REVIEW CHECKLIST FOR EXISTING CONDITION OF CURB RAMPS ADA COMPLIANCE

PROJECT ID: **6020-04-02/72**

INTERSECTION: HWY: **US 51** SIDEROAD: **Tomlinson Road**

Poynette
Seward Street Intersection, Poynette WI

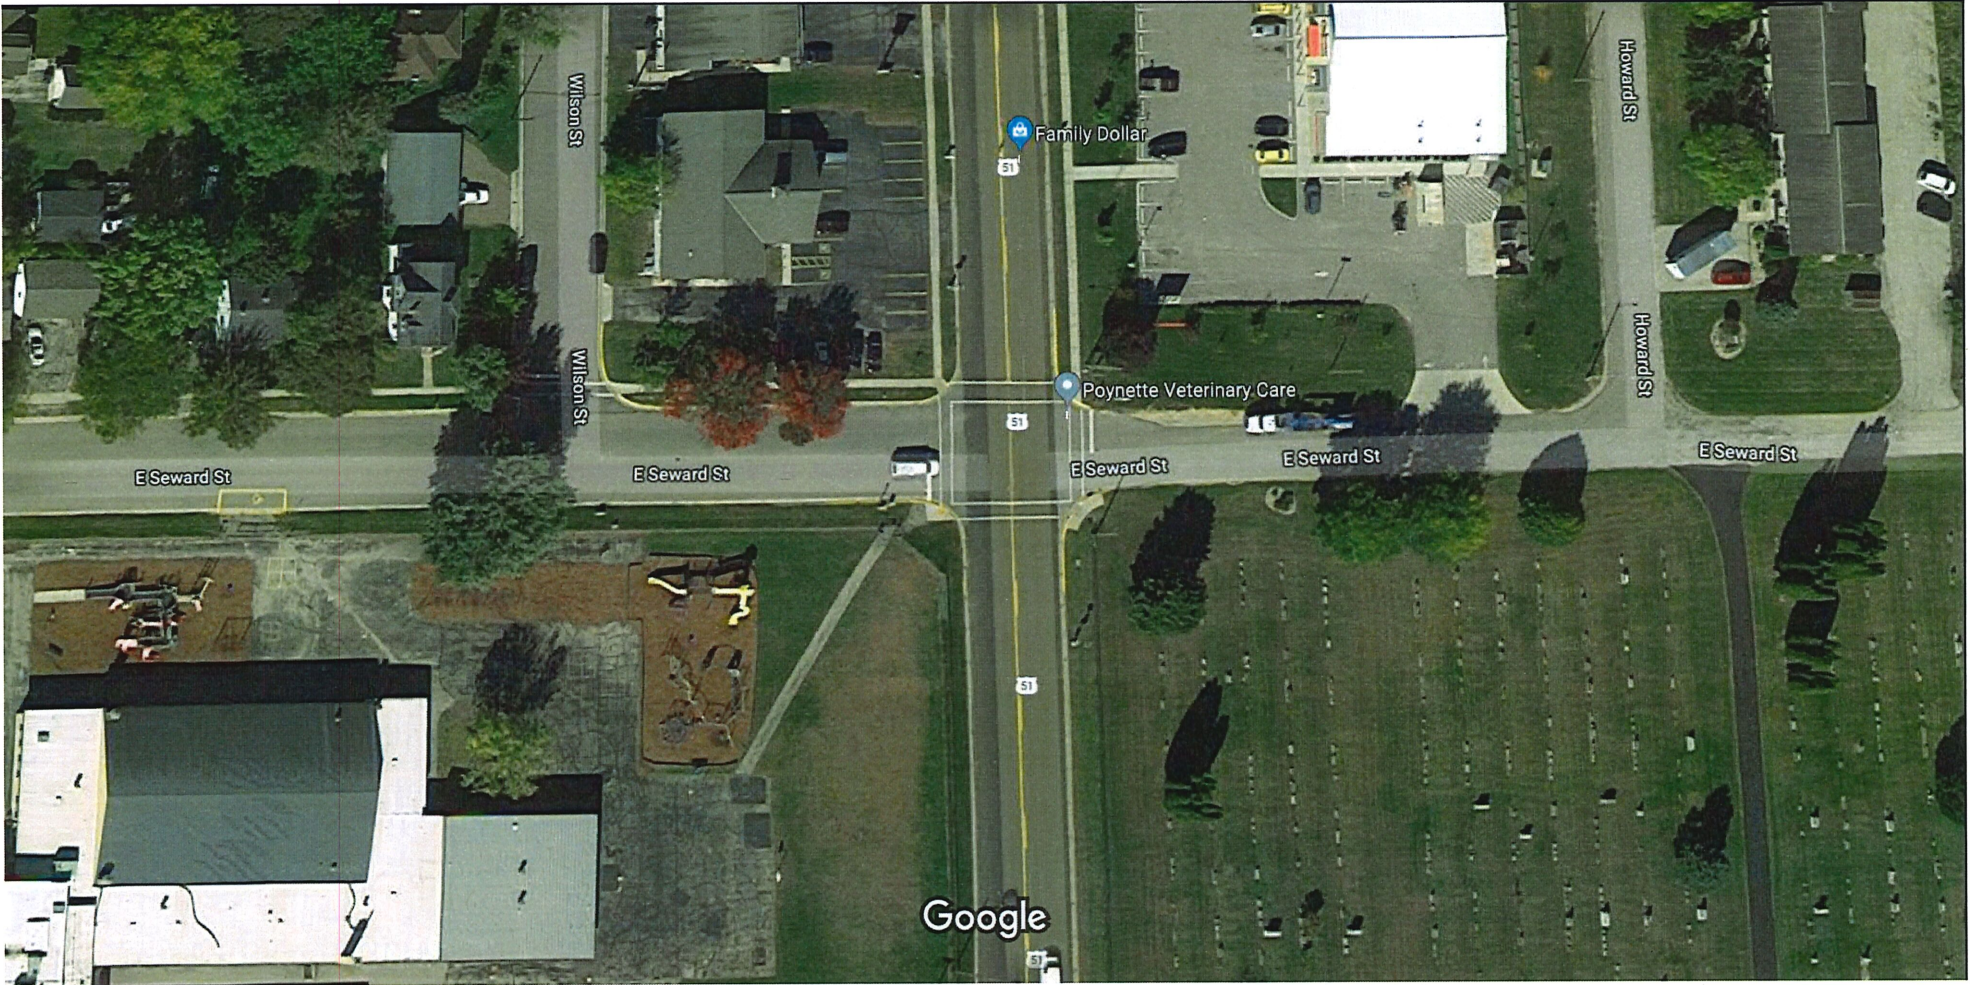
Flashing beacon at intersection.

While NE and SW quads have curb ramps with detectable warning fields, Improve all curb ramps to Type 2 or 3 since schools in SW quad with crosswalks to all quadrants. SE quadrant curb ramps may need to be parallel ramps due to Hillside Cemetery.

RAMP	A	B
TYPE	Type 1 (mid rad-terr)	NONE (served by ramp A)
LONG. SLOPE	8.3 %	%
CROSS SLOPE	1.2 %	%
FLARE SLOPE	%	%
DWF	Stamped	select one
RAMP CONTROL	None	select one
CONDITION	Hairline cracks/no faulting	select one
LANDING AREA	5' " x 4' "	5' " x 4' "
SLOPES	2 % x 1.5 %	1.5 % x 2.2 %
TERRACE	6.4' "	6.5' "
EXT. LONG. SLOPE	3.3 %	%
EXT. CROSS SLOPE	%	%
PORK CHOP	NO	NO
COMMENTS:	Set up new ramps as Type 2 or 3

RAMP	A	B
TYPE	NONE	Type 1 (center radius - terrace)
LONG. SLOPE	%	7.3 %
CROSS SLOPE	%	2.2 %
FLARE SLOPE	%	%
DWF	select one	Plate w/ truncated domes (squa
RAMP CONTROL	select one	None
CONDITION	select one	Excellent
LANDING AREA	' " x ' "	4' " x 4' "
SLOPES	% x %	2 % x 0.9 %
TERRACE	6.2' "	0' "
EXT. LONG. SLOPE	%	%
EXT. CROSS SLOPE	%	%
PORK CHOP	NO	NO
COMMENTS:	Set up new ramp as Type 2 or 3

RAMP	A	B
TYPE	NONE	Type 1a (center radius - no terra
LONG. SLOPE	%	6.8 %
CROSS SLOPE	%	3.3 %
FLARE SLOPE	%	%
DWF	select one	Plate w/ truncated domes (squa
RAMP CONTROL	select one	None
CONDITION	select one	Excellent
LANDING AREA	' " x ' "	' None" x ' "
SLOPES	% x %	% x %
TERRACE	11.2' to fence"	9.8' to fence"
EXT. LONG. SLOPE	%	%
EXT. CROSS SLOPE	%	%
PORK CHOP	NO	NO
COMMENTS:	Set up new ramps as Type 2 or 3

RAMP	A	B
TYPE	Type 1a (mid rad-no terr)	NONE (served by ramp A)
LONG. SLOPE	11.9 %	%
CROSS SLOPE	1.6&2.7 %	%
FLARE SLOPE	%	%
DWF	Stamped	select one
RAMP CONTROL	None	select one
CONDITION	Hairline cracks/no faulting	select one
LANDING AREA	' None" x ' "	' " x ' "
SLOPES	% x %	% x %
TERRACE	0' "	12' to fence"
EXT. LONG. SLOPE	%	%
EXT. CROSS SLOPE	%	%
PORK CHOP	NO	NO
COMMENTS:	inlet behind sidewalk. Cemetery, try to set up as Type 2 or 3 if possible. May need to be parallel ramps.

Poynette
E Tomlinson Street Intersection, Poynette WI

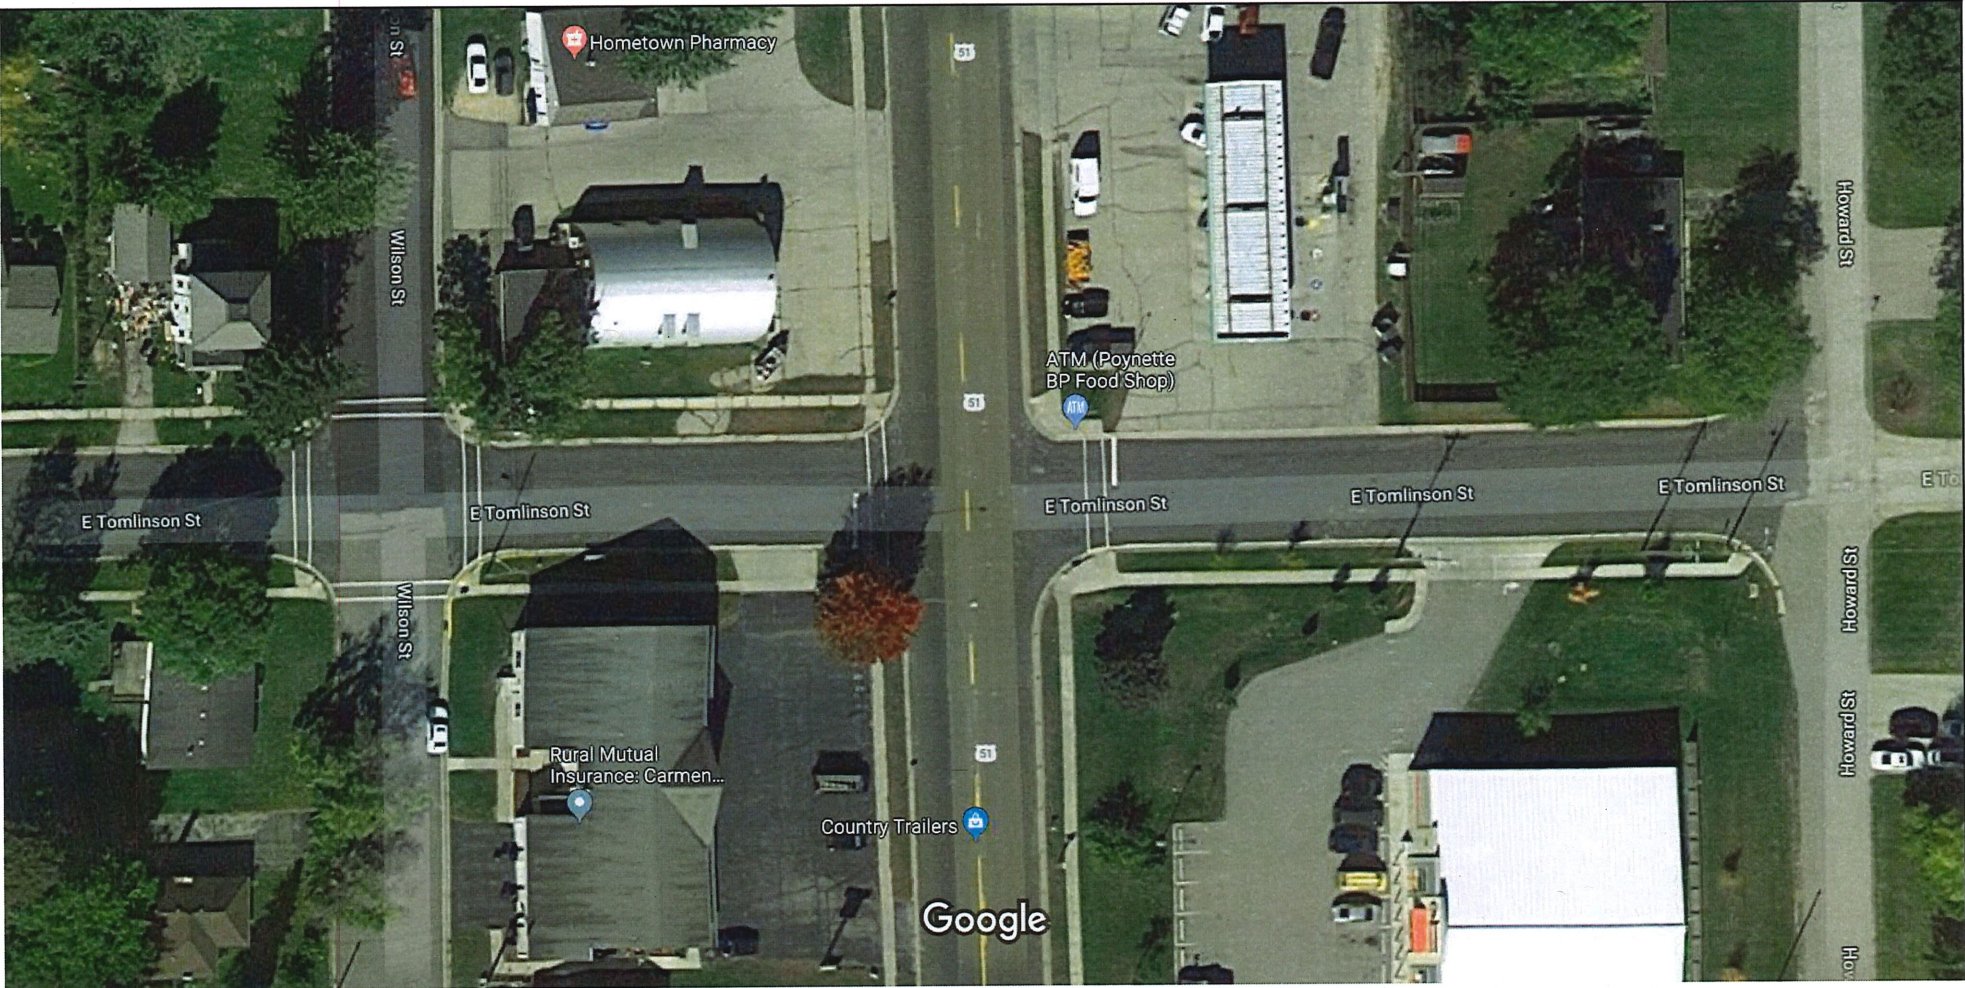
Replace all curb ramps as Type 2 or 3.

NW QUADRANT (305 Highway 51)				NE QUADRANT (BP Gas/Convenience)			
RAMP	A	B		RAMP	A	B	
TYPE	Type 2 (inline w/ sidewalk)	Type 2 (on line w/ sidewalk)		TYPE	Type 3 (offset w/ sidewalk)	Type 3 (offset w/ sidewalk)	
LONG. SLOPE	7.2 %	2.5 %		LONG. SLOPE	8.3 %	8.1 %	
CROSS SLOPE	0.2 %	0.4 %		CROSS SLOPE	2.2 %	1.4 %	
FLARE SLOPE	%	%		FLARE SLOPE	%	%	
DWF	Stamped	Stamped		DWF	Stamped	Stamped	
RAMP CONTROL	None	None		RAMP CONTROL	None	None	
CONDITION	Weeds	Weeds		CONDITION	Excellent	Excellent	
LANDING AREA	4' " x 4' "	' serves" x "		LANDING AREA	4' " x 5' "	4' " x 4' "	
SLOPES	0.2 % x 4.1 %	both % x %		SLOPES	2.9 % x 0.9 %	0.9 % x 1.2 %	
TERRACE	6.3' "	8.9' "		TERRACE	6.1' "	0' 6.7' to R/W"	
EXT. LONG. SLOPE	%	%		EXT. LONG. SLOPE	%	%	
EXT. CROSS SLOPE	%	%		EXT. CROSS SLOPE	%	%	
PORK CHOP	NO	NO		PORK CHOP	NO	NO	
COMMENTS:	Replace as Type 2 or 3s			COMMENTS:	Replace as Type 2 or 3s

E Hudson Street Intersection, Poynette WI

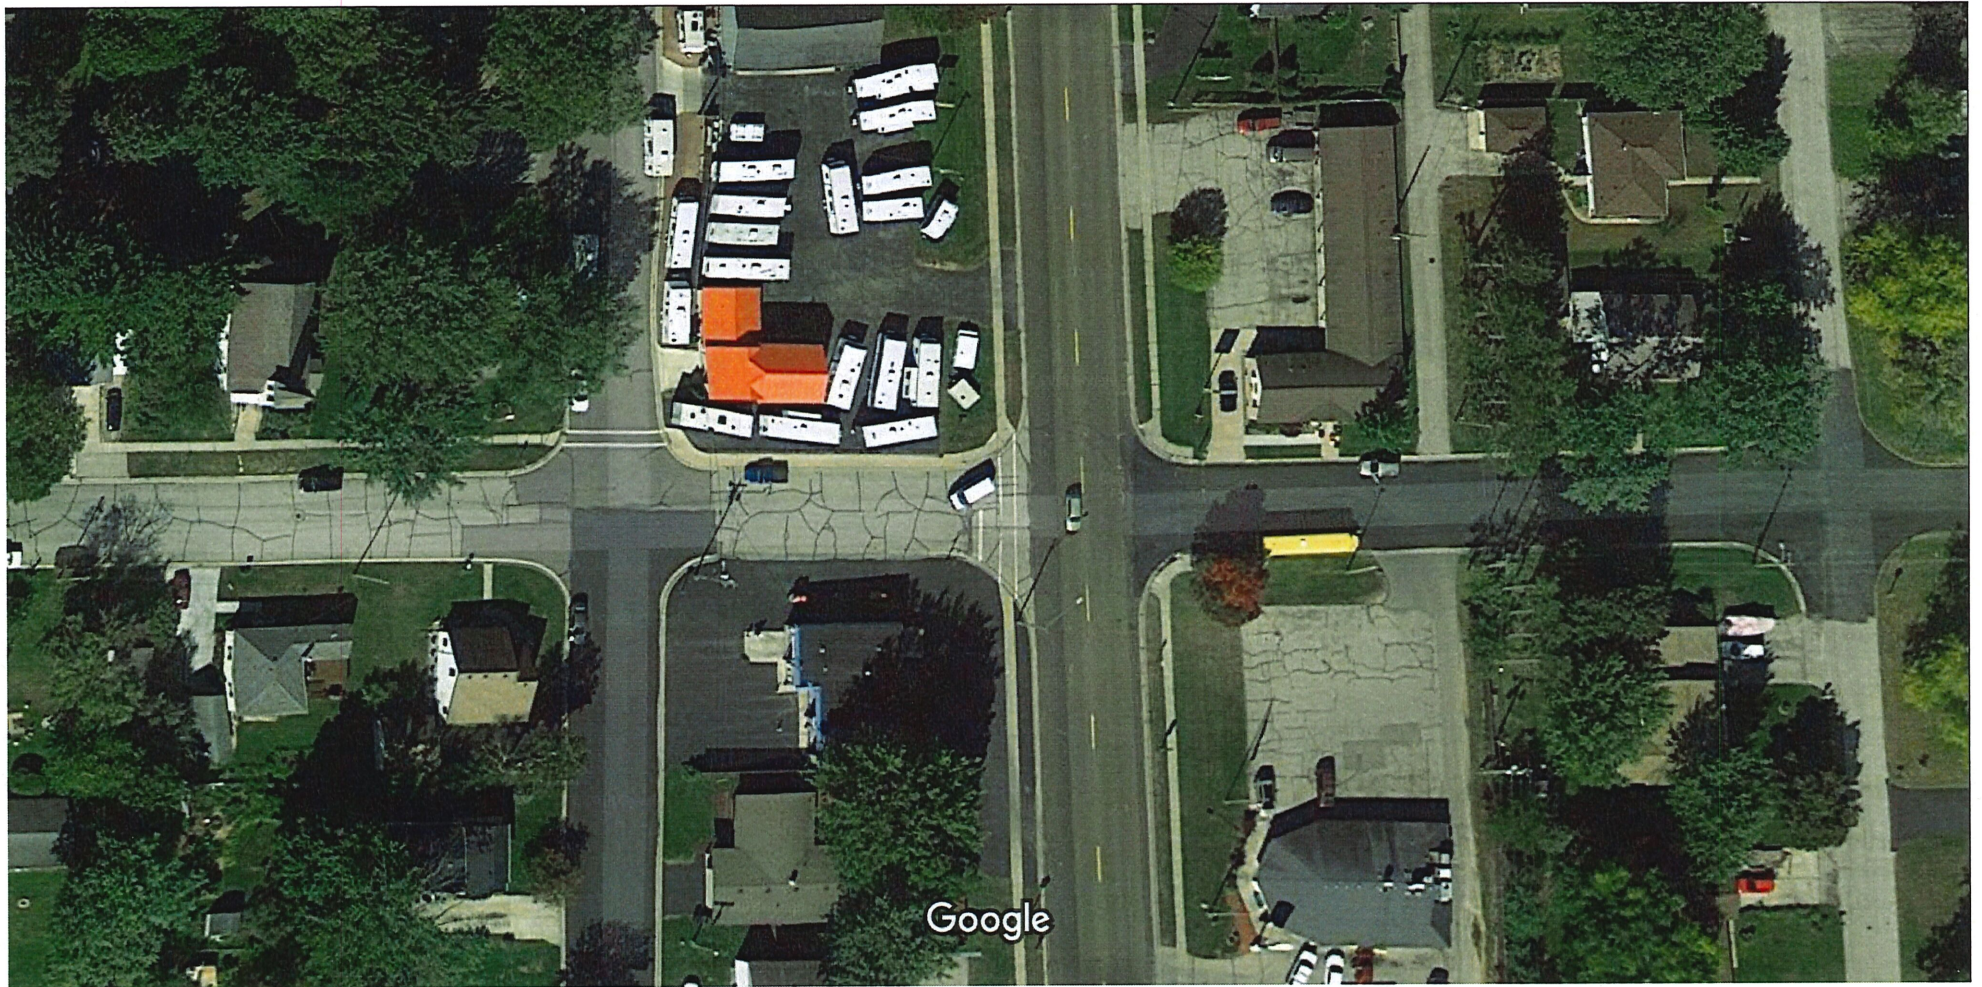
Replace curb ramps as indicated on reverse.

NW QUADRANT (<i>Interstate RV</i>)			NE QUADRANT (<i>The Watering Can Floral and Gifts</i>)			
RAMP	A	B	HWY: US 51	RAMP	A	B
TYPE	NONE (served by ramp B)	Type 4B (parallel - terrace)	VEHICULAR INTERSECTION CONTROL: Through MEDIAN ISLAND: NONE COMMENTS:	TYPE	Type 3 (offset w/ sidewalk)	Type 3 (offset w/ sidewalk)
LONG. SLOPE	%	2.4 %		LONG. SLOPE	8.9 %	6.2 %
CROSS SLOPE	%	2 %		CROSS SLOPE	1.7 %	5.2 %
FLARE SLOPE	%	%		FLARE SLOPE	%	%
DWF	None	Stamped		DWF	Stamped	Stamped
RAMP CONTROL	select one	None		RAMP CONTROL	None	None
CONDITION	select one	Weeds		CONDITION	Weeds	Weeds
LANDING AREA	4' 0" x 5' 0"	4' 0" x 5' 0"		LANDING AREA	3' 0" x 5' 0"	4' 0" x 5' 0"
SLOPES	1.3 % x 0.9 %	1.2 % x 4.4 %		SLOPES	1.2 % x 0.5 %	0.4 % x 2.2 %
TERRACE	6.2' "	0' 0"		TERRACE	6.3' "	5.7' "
EXT. LONG. SLOPE	%	%		EXT. LONG. SLOPE	%	%
EXT. CROSS SLOPE	%	%		EXT. CROSS SLOPE	%	%
PORK CHOP	NO	NO		PORK CHOP	NO	NO
COMMENTS:	Replace as Type 2 or 3 if possible			COMMENTS:	Replace Type 3s

SLOPES	2.9 % x 2.2 %	% x %		SLOPES	% x %	1.0 % x 4.5 %
TERRACE	~4.5' "	6.0' "		TERRACE	~6.6' to R/W"	6.3' "
EXT. LONG. SLOPE	%	%		EXT. LONG. SLOPE	%	%
EXT. CROSS SLOPE	%	%		EXT. CROSS SLOPE	%	%
PORK CHOP	NO	NO		PORK CHOP	NO	NO
COMMENTS:	Replace as Type 2 or 3 if possible. Provide separation between curb ramp and driveway.			COMMENTS:	Replace Type 3s

E Grant Street Intersection, Poynette WI

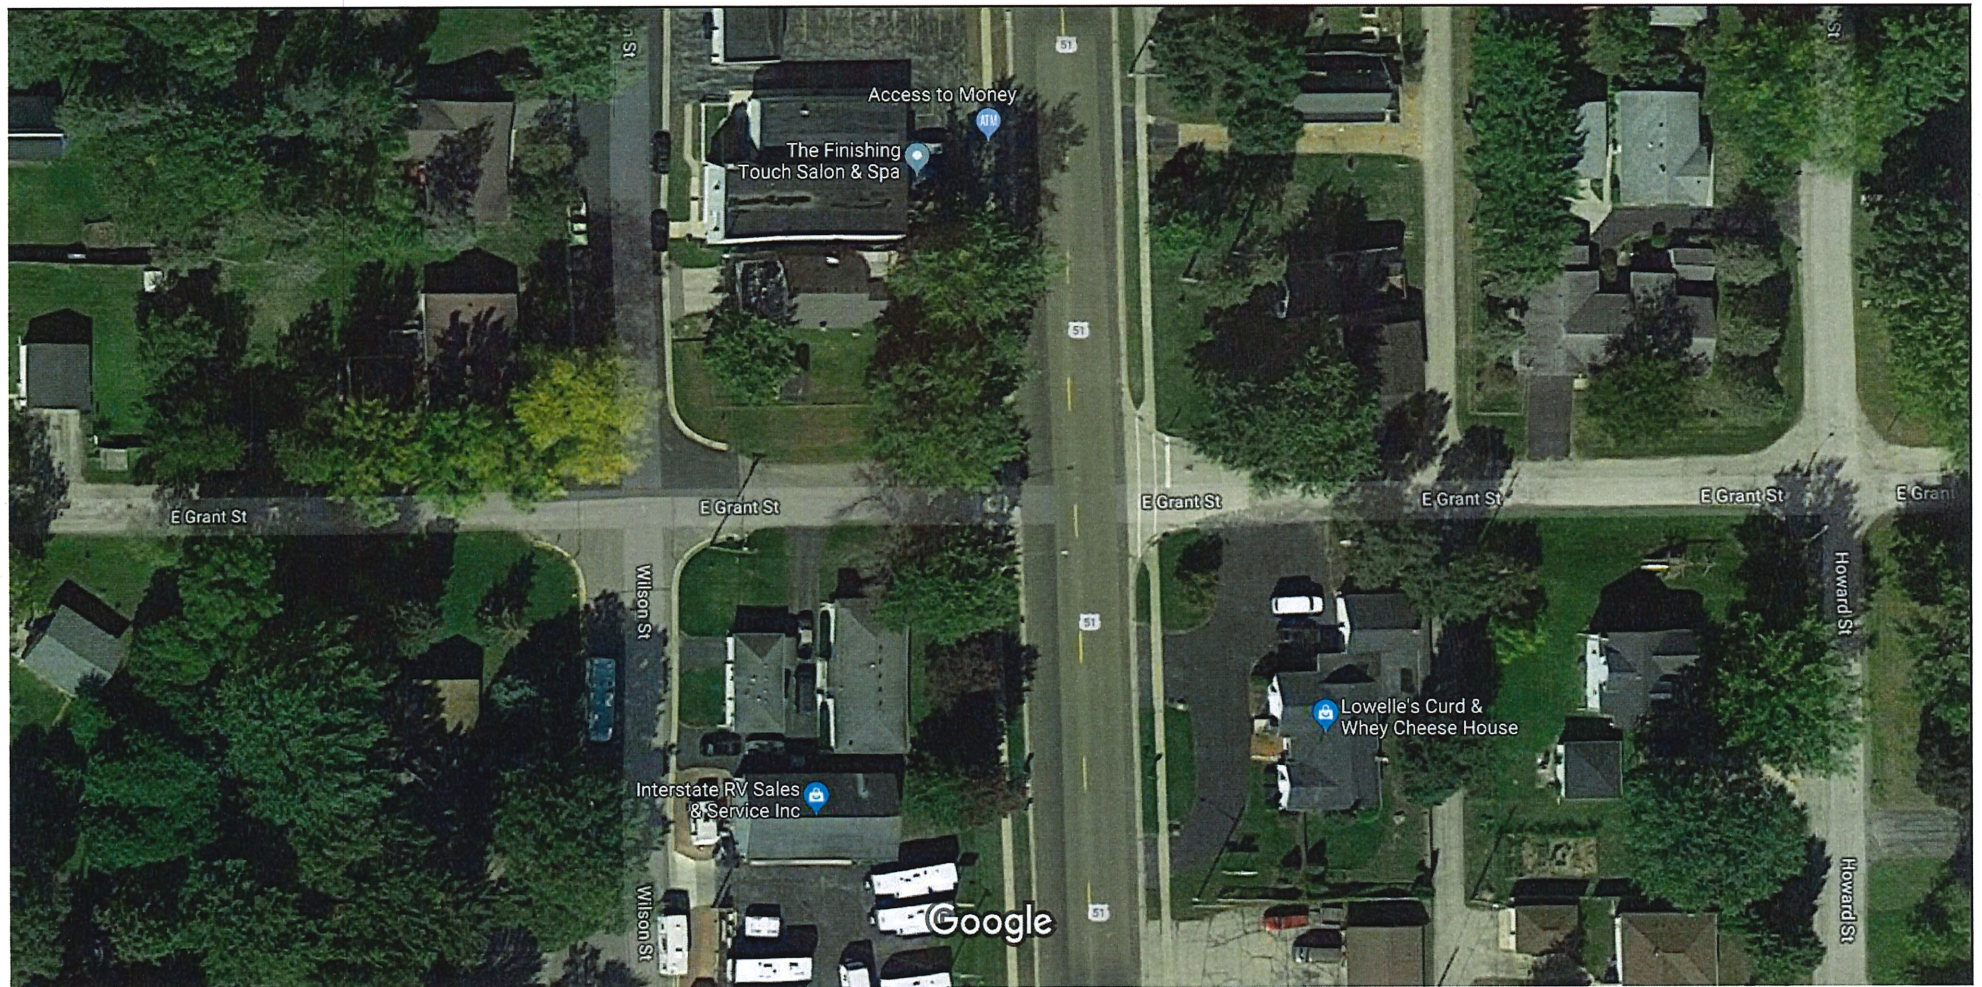
Replace all Type 4B curb ramps. No need for ramps across USH 51 since no sidewalk on Grant St.

RAMP	A	B
TYPE	NONE	Type 4B (parallel - terrace)
LONG. SLOPE	%	10.5 %
CROSS SLOPE	%	1.2 %
FLARE SLOPE	%	%
DWF	select one	Stamped
RAMP CONTROL	select one	None
CONDITION	select one	Weeds
LANDING AREA	' " x "	4' 0" x 5' 0"
SLOPES	% x %	0.7 % x 0.7 %
TERRACE	6.4' "	0' 0"
EXT. LONG. SLOPE	%	%
EXT. CROSS SLOPE	%	%
PORK CHOP	NO	NO
COMMENTS:	Replace Type 4 ramp

RAMP	A	B
TYPE	NONE	Type 4B (parallel - terrace)
LONG. SLOPE	%	12.0 %
CROSS SLOPE	%	5.2 %
FLARE SLOPE	%	%
DWF	select one	Stamped
RAMP CONTROL	select one	None
CONDITION	select one	Weeds
LANDING AREA	' " x "	4' 0" x 5' 0"
SLOPES	% x %	2.3 % x 2.6 %
TERRACE	6.1' "	0' 0"
EXT. LONG. SLOPE	%	%
EXT. CROSS SLOPE	%	%
PORK CHOP	NO	NO
COMMENTS:	Replace Type 4 ramp

RAMP	A	B
TYPE	Type 4B (parallel - terr)	select one
LONG. SLOPE	6.3 %	%
CROSS SLOPE	1.3 %	%
FLARE SLOPE	%	%
DWF	Stamped	select one
RAMP CONTROL	None	select one
CONDITION	Weeds	select one
LANDING AREA	4' 0" x 5' 0"	' " x "
SLOPES	0.1 % x 1.6 %	% x %
TERRACE	0' 0"	6.3' "
EXT. LONG. SLOPE	%	%
EXT. CROSS SLOPE	%	%
PORK CHOP	NO	NO
COMMENTS:	Replace Type 4 ramp

RAMP	A	B
TYPE	Type 4B (parallel - terr)	select one
LONG. SLOPE	14.2 %	%
CROSS SLOPE	4.6 %	%
FLARE SLOPE	%	%
DWF	Stamped	select one
RAMP CONTROL	None	select one
CONDITION	>1/2" cracks-faulting	select one
LANDING AREA	' None" x ' "	' " x ' "
SLOPES	5.7 % x %	% x %
TERRACE	0' 0"	5.9' "
EXT. LONG. SLOPE	%	%
EXT. CROSS SLOPE	%	%
PORK CHOP	NO	NO
COMMENTS:	Replace Type 4 ramp
